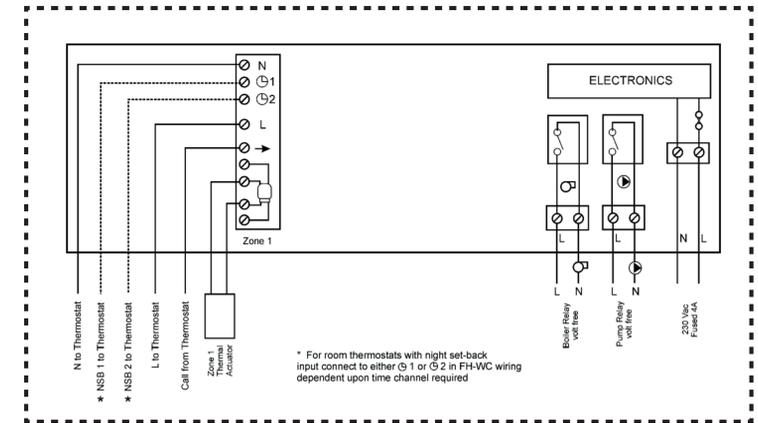
1 - If brown is "switch / call" it does not seem correct to me that it goes into perm live here?
